Manchester Art Gallery

Roof Lantern Replacement [Ref: 137015/LO/2023]
Discharge of Condition 3, Item 3
December 2024

Figure 5 Previously proposed glazing bar timber capping profile submitted as part of 137015/LO/2023

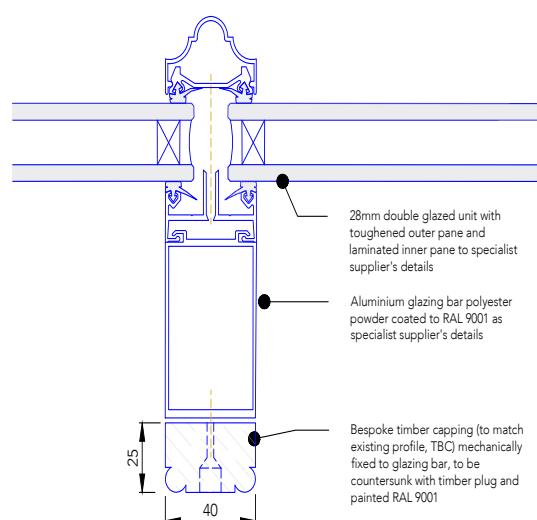
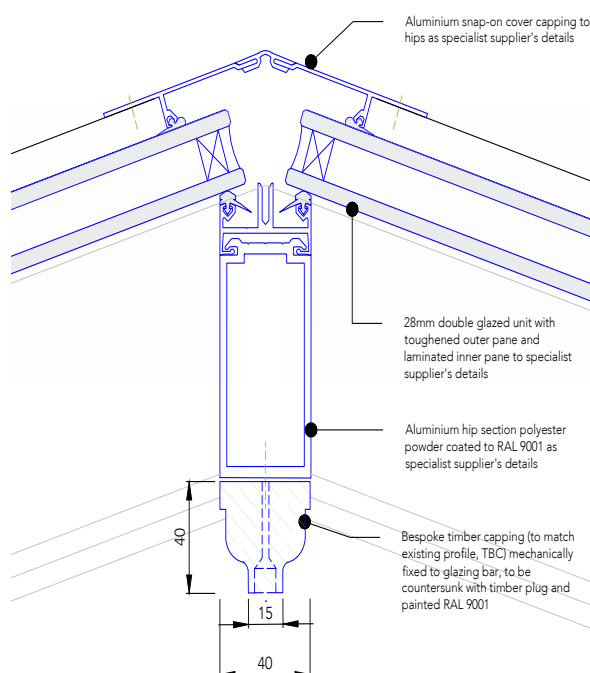
The proposal submitted as part of application 137015/LO/2023 included for timber capping pieces to be affixed to the aluminium glazing and hips bars internally, to match the existing assumed timber profiles (see Figures 5 and 6 adjacent). The intention was to measure the existing timber profiles once close access to the rooflight could be achieved following the erection of the internal scaffold, and fabricate the timber profiles accordingly.

A visit to the view the rooflight was undertaken on 02/12/24 between Buttress Architects, Robertson Construction and the Manchester City Council (MCC) Planning and Conservation Officers, and it was found upon close inspection that there are no existing timber mouldings to the glazing bars, hip rafters or central boss as existing. The hip rafter comprises of two inverted steel angles, and the glazing bars have a simple flat steel capping piece applied (see Figures 1-4 on the previous page).

In light of this information, and with no existing profiles to replicate, the intention is to omit the internal timber mouldings to the aluminium hip rafters and glazing bars. A circular boss is still proposed at the apex to match the existing appearance. This was agreed in principle with MCC during the site visit on 02/12/24.

TITLE:
REPLACEMENT LANTERN LIGHT
PLAN, ELEVATION AND SPECIFICATION

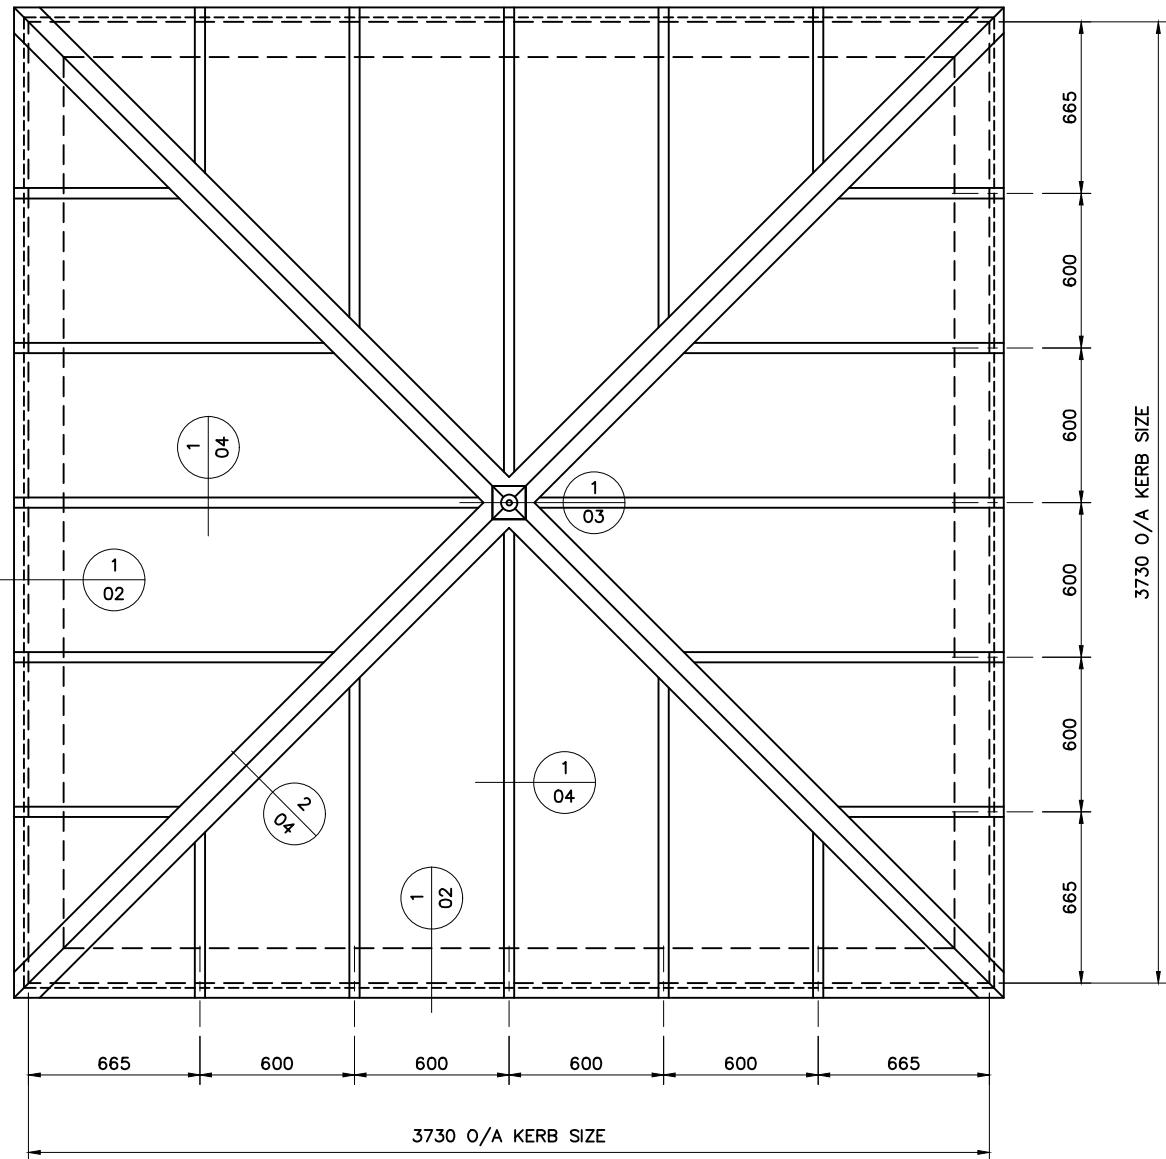
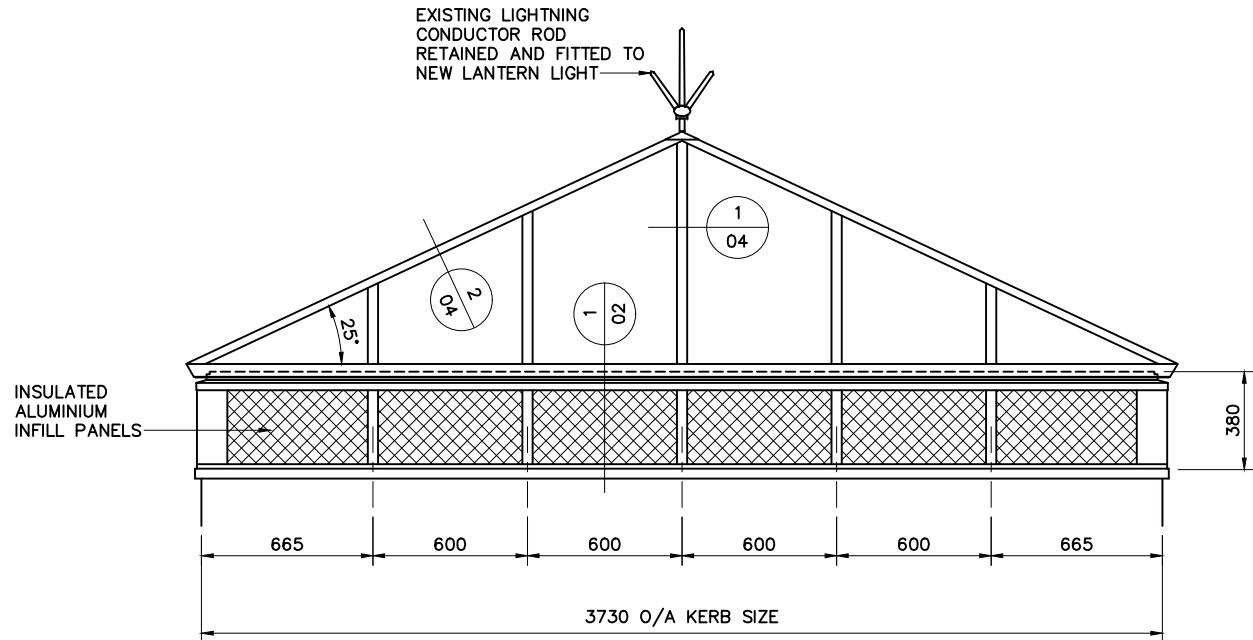
C01	EXTERNAL COLOUR OF INFILL PANEL REVISED; 60 MICRONS ADDED TO ALL COLOURS; TITLE BLOCK REVISED	PD	22.11.2024
D	LADDER RAIL REMOVED; INTERNAL COLOUR CREAM CONFIRMED ISSUED FOR CONSTRUCTION	PD	6.10.2024
C	THICKNESS OF INNER PANE OF DGU ALTERED FROM 6.8MM. LAM. TO 9.5MM. LAM.; TRICKLE VENTS REMOVED; TUBULAR LADDER RAIL ADDED	PD	13.2.2024
B	ROOF PITCH ALTERED FROM 30° TO 25°; SYSTEM REFERENCE CORRECTED	PD	14.12.2023
A	DGU'S TO VERTICAL FRAMES ALTERED TO ALUMINIUM INFILL PANELS; TRICKLE VENTS ADDED; RAFTER BOX SECTIONS ALTERED TO HERITAGE SECTIONS	PD	8.12.2023
REV:	DESCRIPTION:	BY:	DATE:

TITLE:
REPLACEMENT LANTERN LIGHT
CILL AND VERTICAL FRAME DETAIL

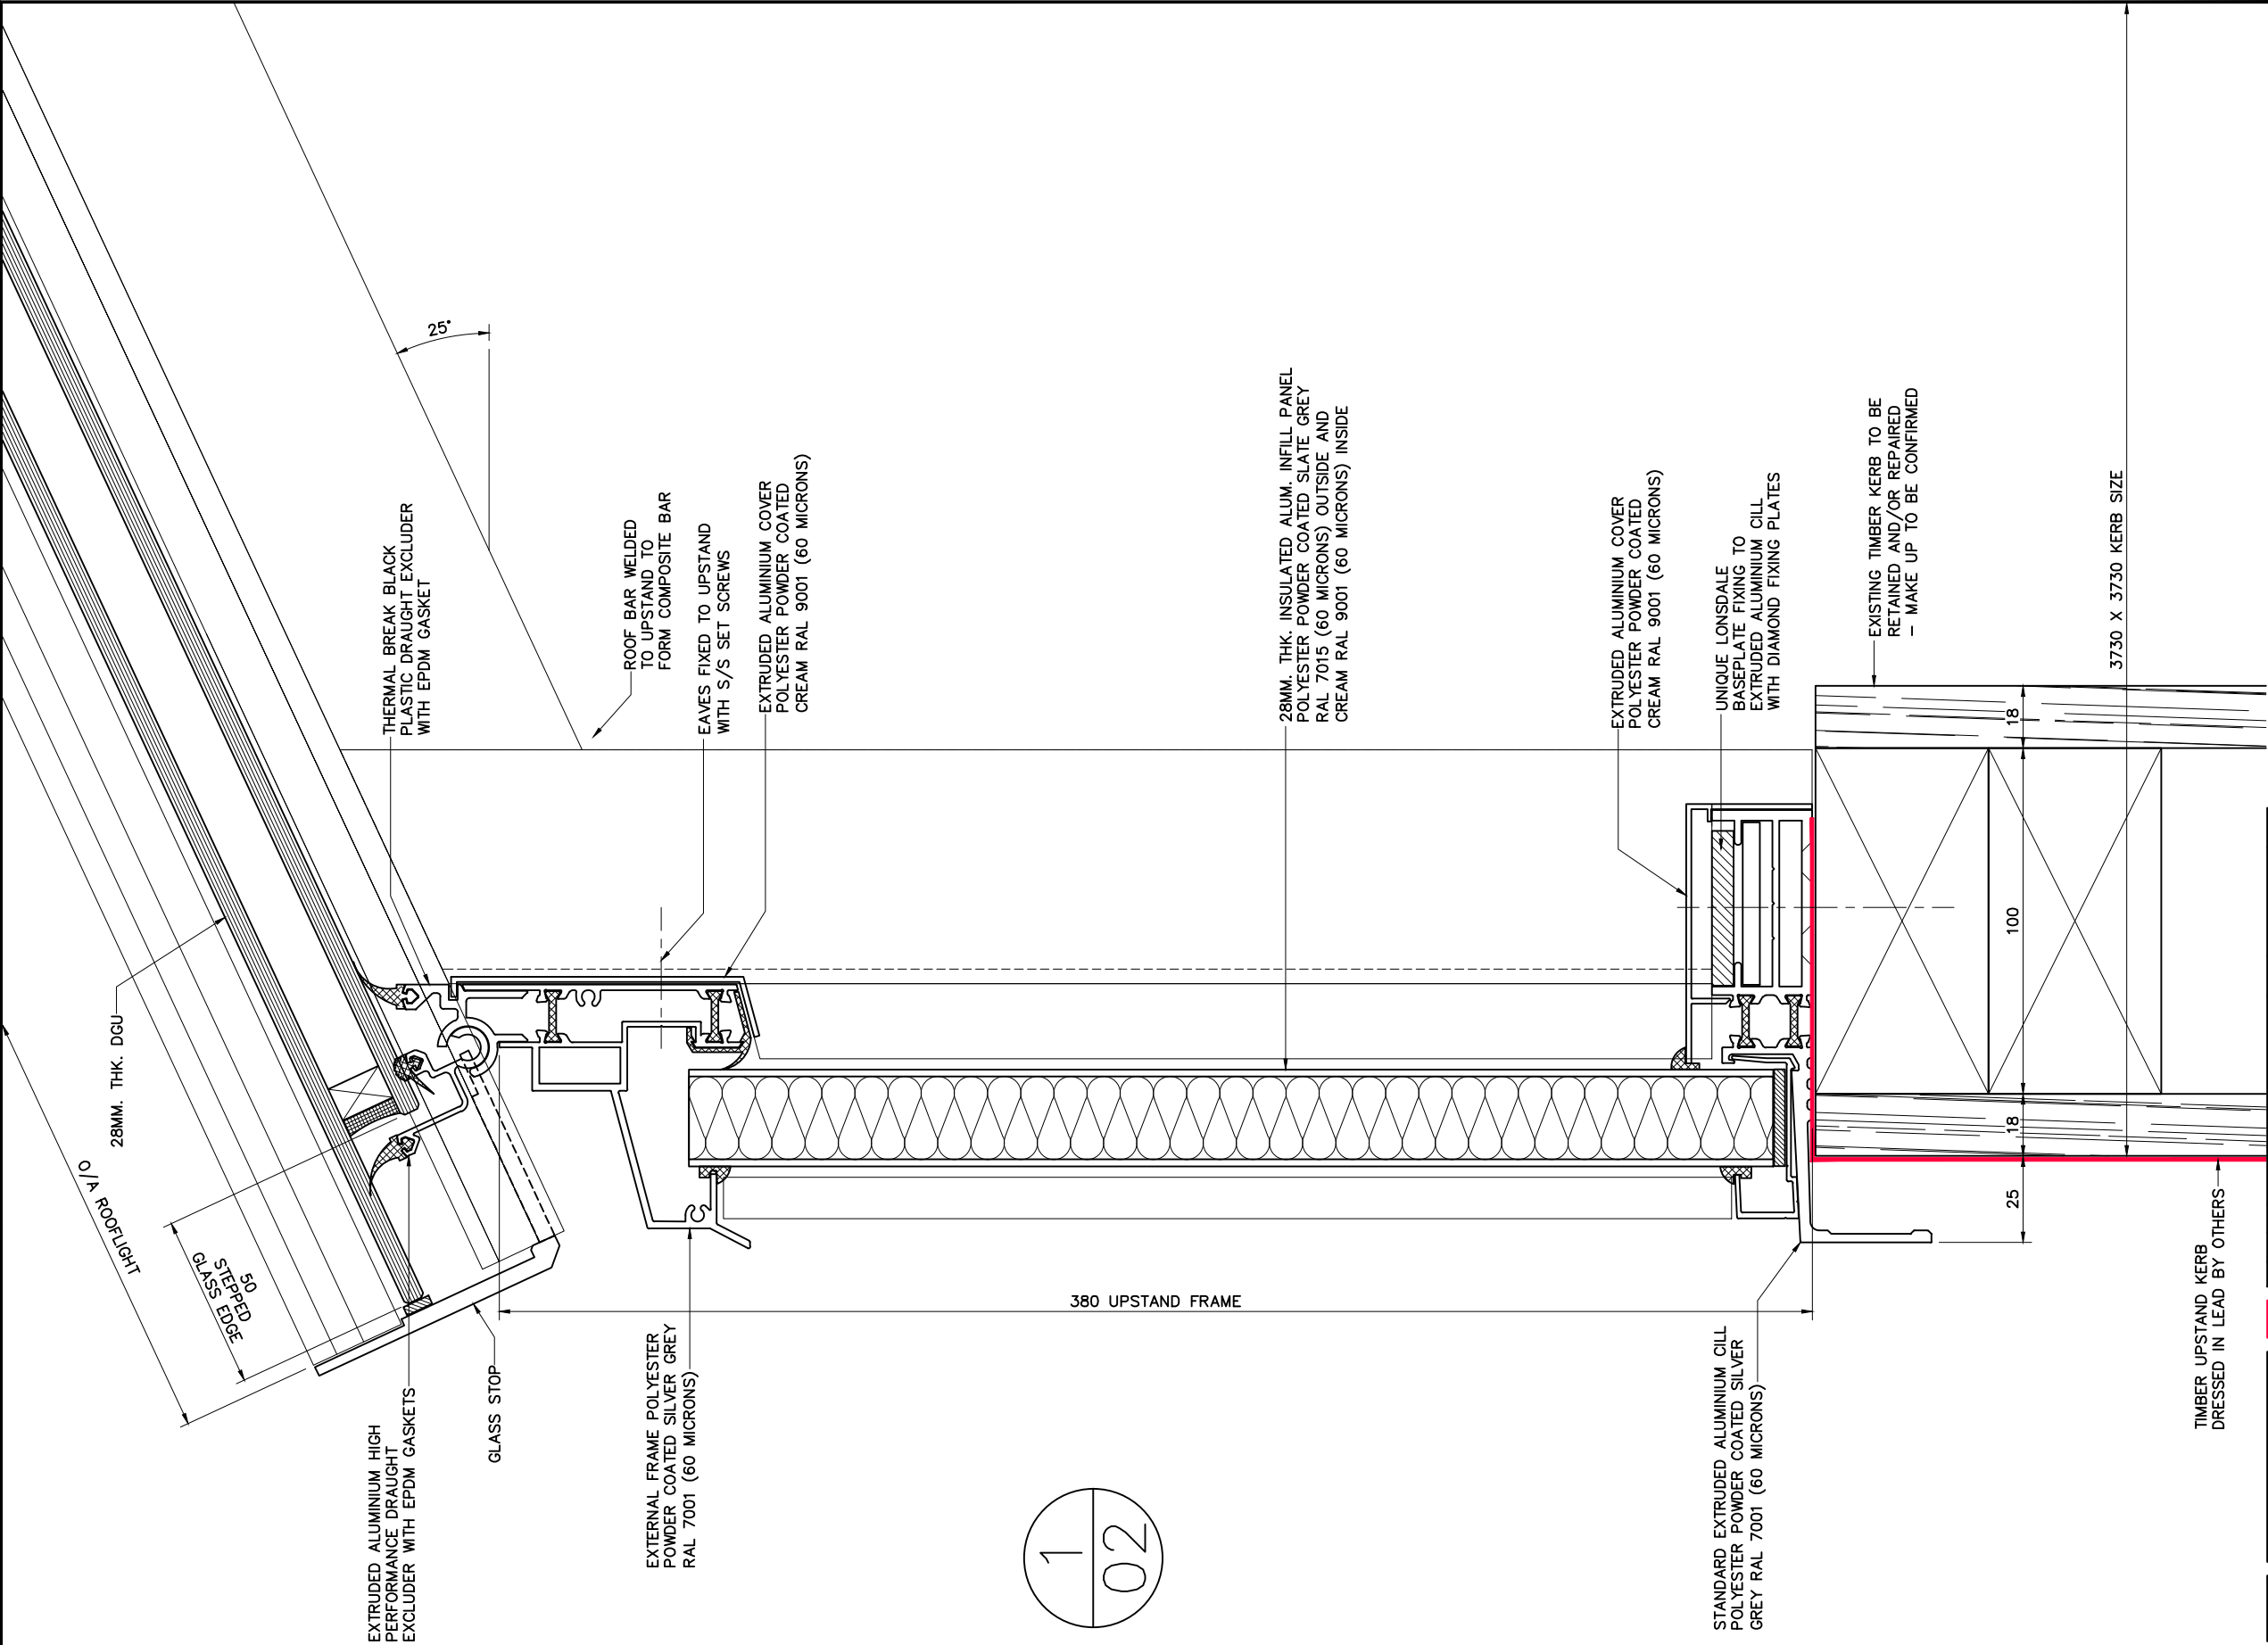
C01	INTERNAL BESPOKE TIMBER CAPPING REMOVED; EXTERNAL COLOUR OF INFILL PANEL REVISED; 60 MICRONS ADDED TO ALL COLOURS; TITLE BLOCK REVISED	PD	22.11.2024
E	LADDER RAIL REMOVED ISSUED FOR CONSTRUCTION	PD	6.10.2024
D	INTERNAL HERITAGE PRESSURE PLATE AND SNAP ON COVER CAP REPLACED WITH BESPOKE TIMBER CAPPING; TRICKLE VENT REMOVED; TUBULAR LADDER RAIL ADDED	PD	13.2.2024
C	RAFTER ALTERED FROM 100/1 40MM. TO 100/2 63.5MM.	PD	9.1.2024
B	ROOF PITCH ALTERED FROM 30° TO 25°; HERITAGE CAP ADDED TO RAFTER INTERNALLY	PD	14.12.2023
A	DGU TO VERTICAL FRAME ALTERED TO ALUMINIUM INFILL PANEL; TRICKLE VENT ADDED	PD	8.12.2023
REV:	DESCRIPTION:	BY:	DATE:

TITLE:
REPLACEMENT LANTERN LIGHT
ROOFLIGHT APEX DETAIL

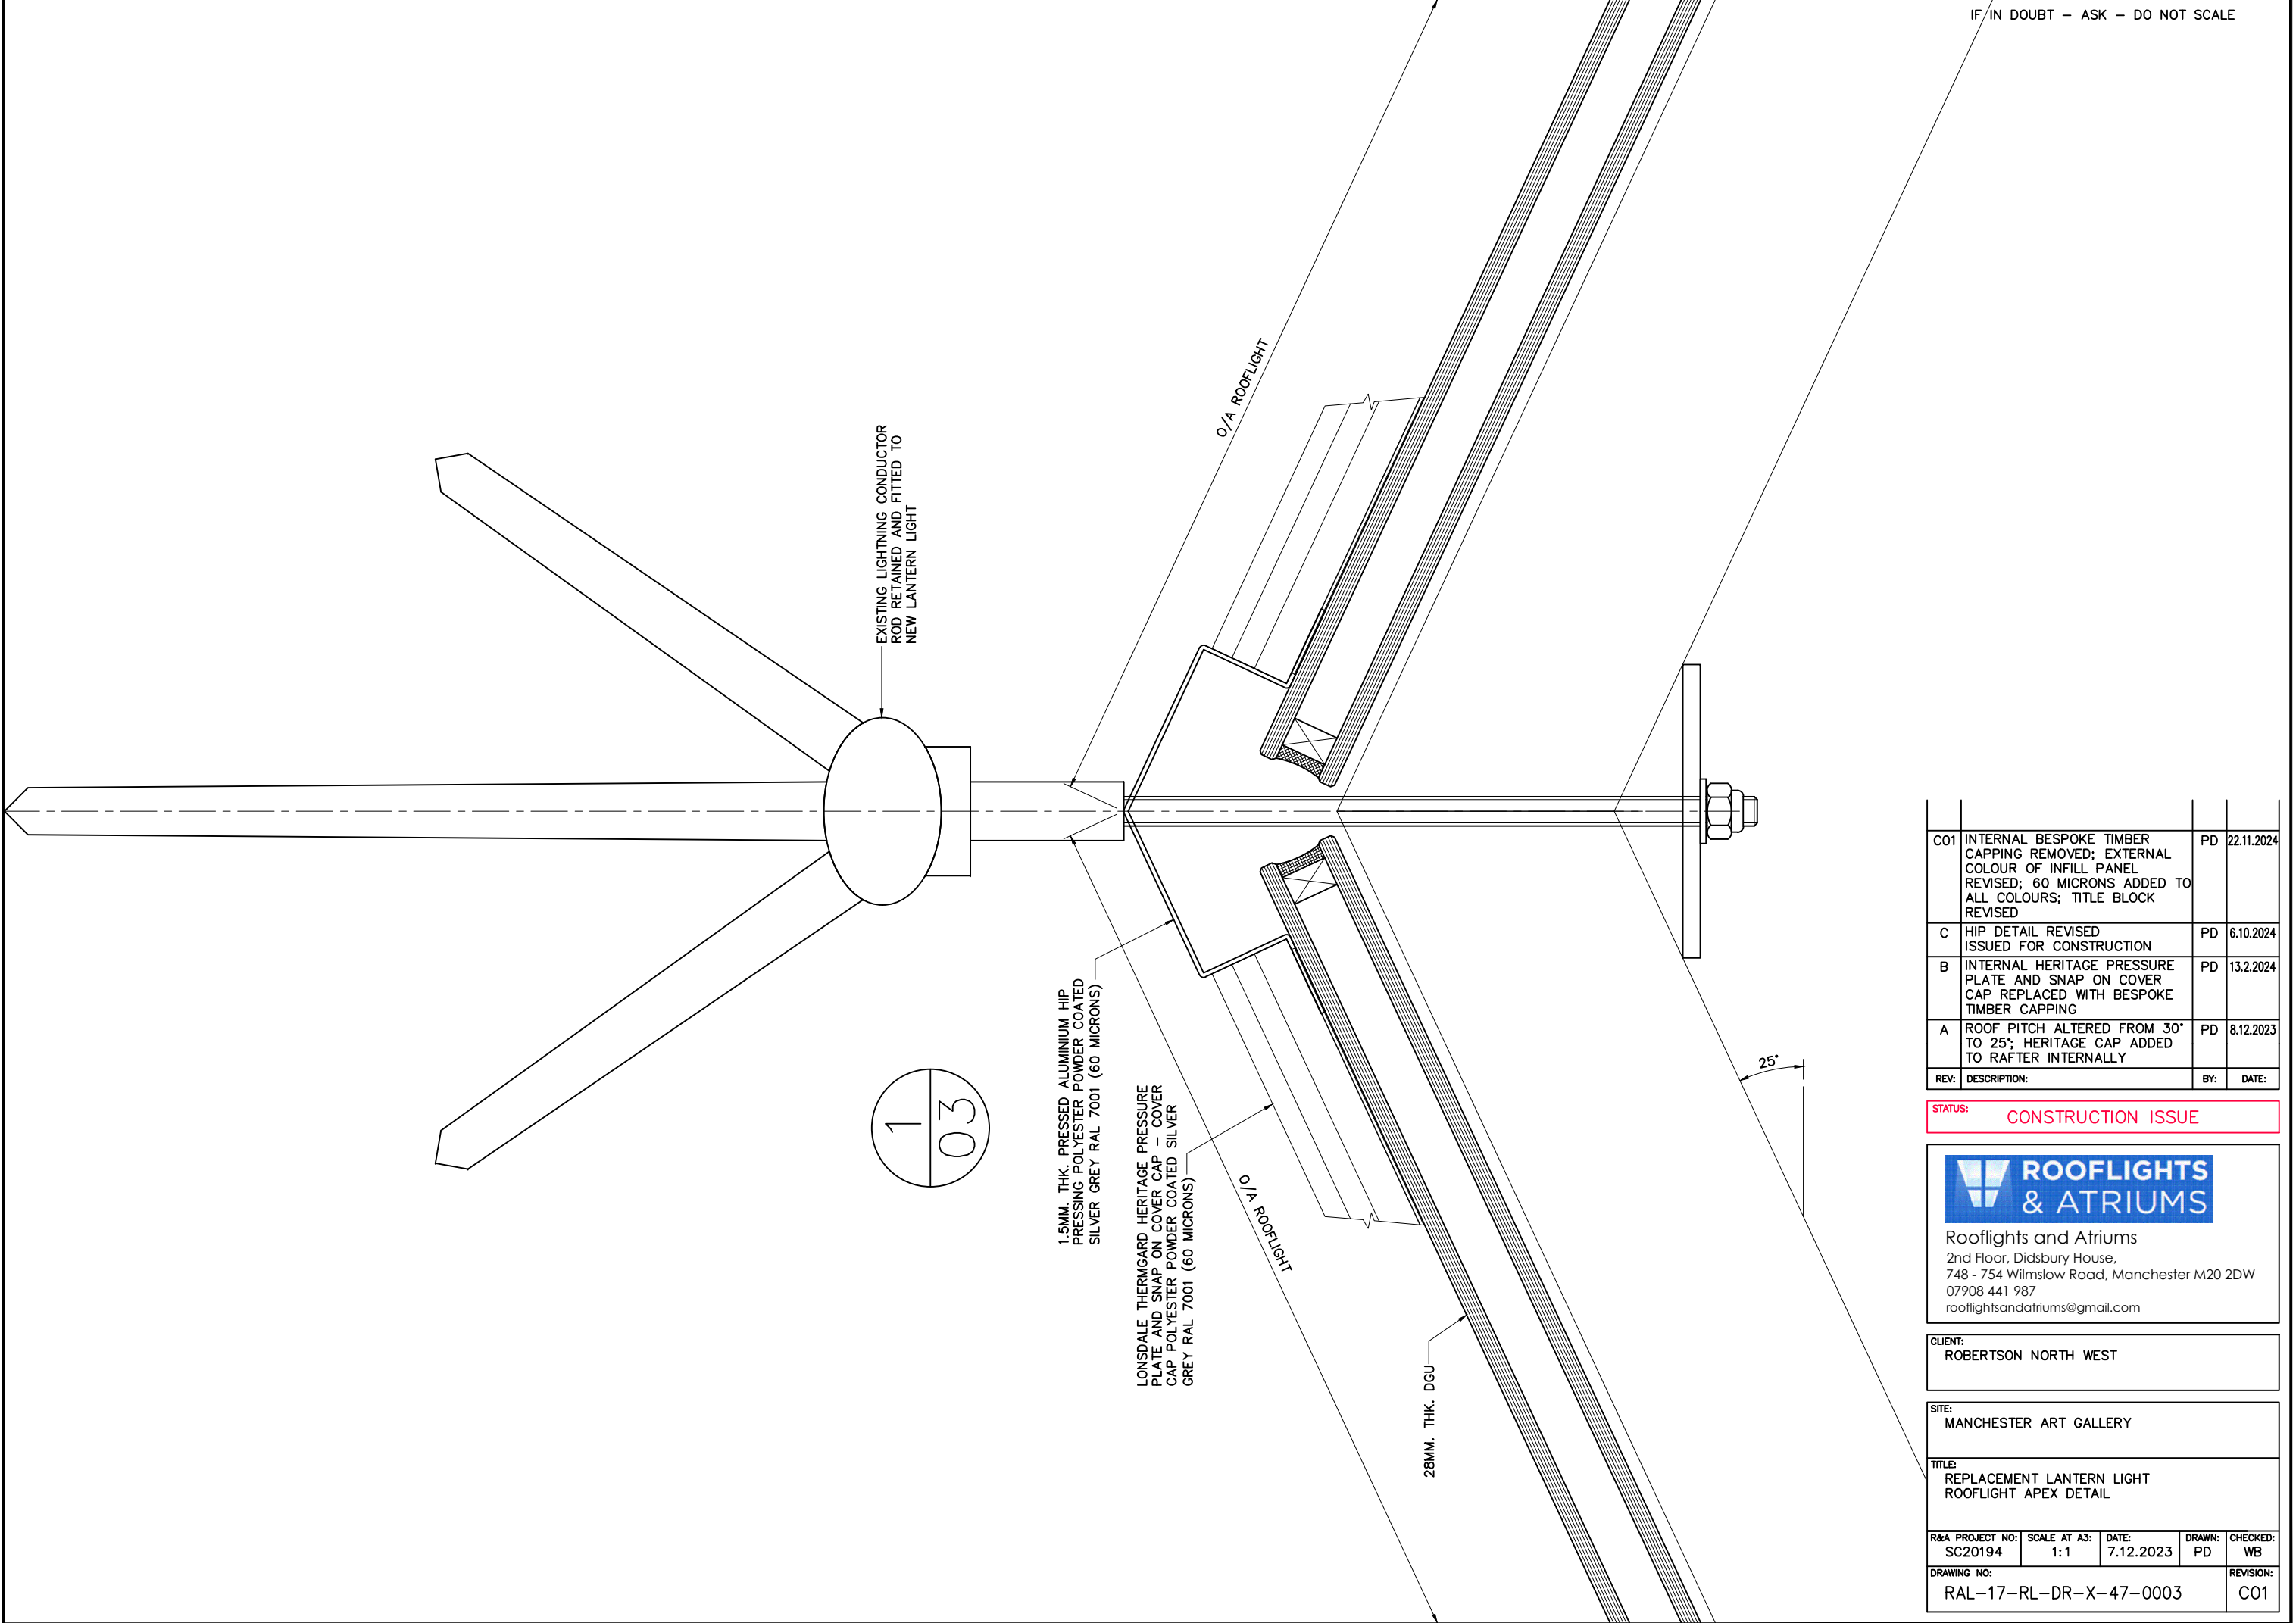
CO1	INTERNAL BESPOKE TIMBER CAPPING REMOVED; EXTERNAL COLOUR OF INFILL PANEL REVISED; 60 MICRONS ADDED TO ALL COLOURS; TITLE BLOCK REVISED	PD	22.11.2024
C	HIP DETAIL REVISED ISSUED FOR CONSTRUCTION	PD	6.10.2024
B	INTERNAL HERITAGE PRESSURE PLATE AND SNAP ON COVER CAP REPLACED WITH BESPOKE TIMBER CAPPING	PD	13.2.2024
A	ROOF PITCH ALTERED FROM 30° TO 25°; HERITAGE CAP ADDED TO RAFTER INTERNALLY	PD	8.12.2023
REV:	DESCRIPTION:	BY:	DATE:
